Facility Name: TMI-2 ISFSI

Change No.: 318936

Activity Description: SPR-173, "CPP-1774 Efflorescence Sampling (ESP-032-07)", Revision 0 is being issued to document the characterization plan for non-invasive sampling of efflorescence on the exterior surfaces of the HSMs to determine chemical constituency.

1. Action: Create Revise Cancel Suspend Document: **SPR-173** Rev: **NEW** Change #: **318936**
Document Title: **CPP-1774 Efflorescence Sampling (ESP-032-07)**

Figure 1.1-1
Location of the INEEL TMI-2 ISFSI

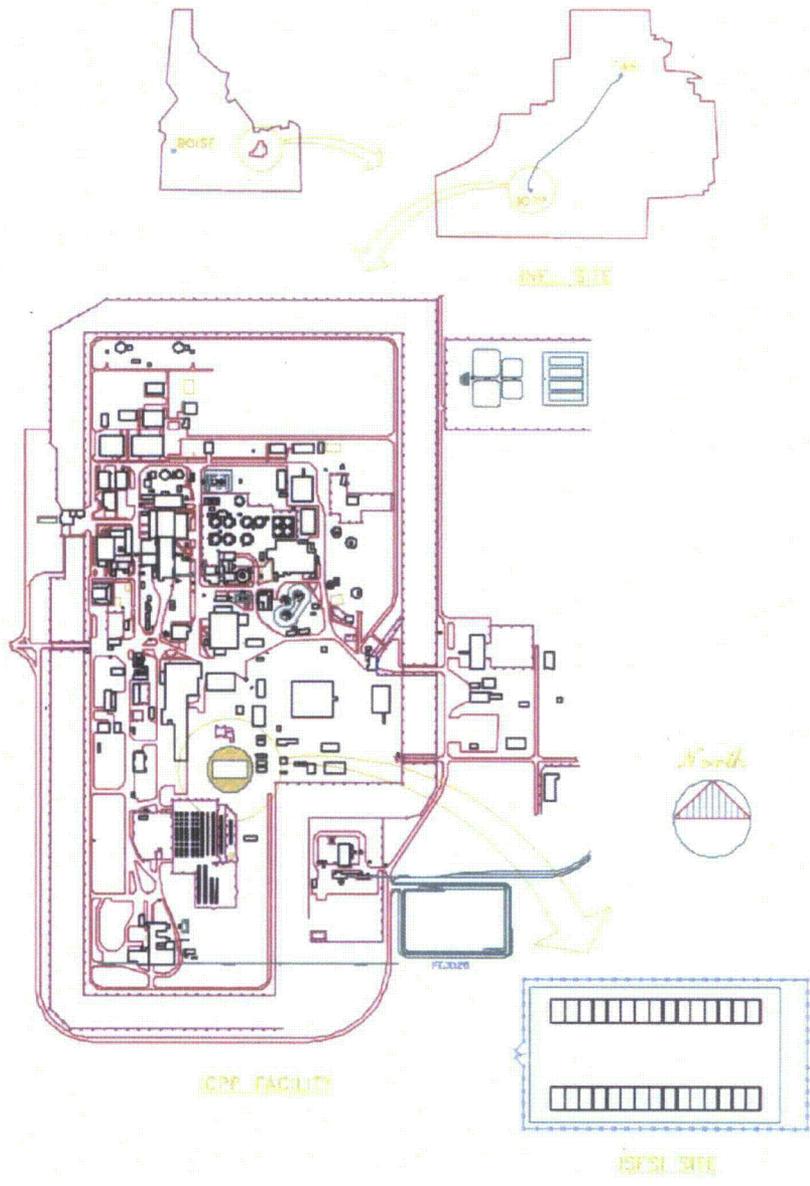
Comment 7244-23:		Section #: General	
/icp_d/df/DRAFT_318936_2_2.doc			
Can a more updated figure be used for figure 1.1-1? One without the terms ICPP, INEL, and INEEL.		Submitted by: Swenson, Kirk Barney representing QUALITY ASSURANCE on 07/31/2007	
Resolution:	Resolved By:	Acceptance Due by:	Accepted/Rejected:
Possibly. I am unaware of any current map of CPP-1774. In all of my EDMS searching, this map was the most detailed in showing where CPP-1774 is located inside the INTEC.	Andersen, Travis Rex on 08/01/2007	08/02/2007	ACCEPTED
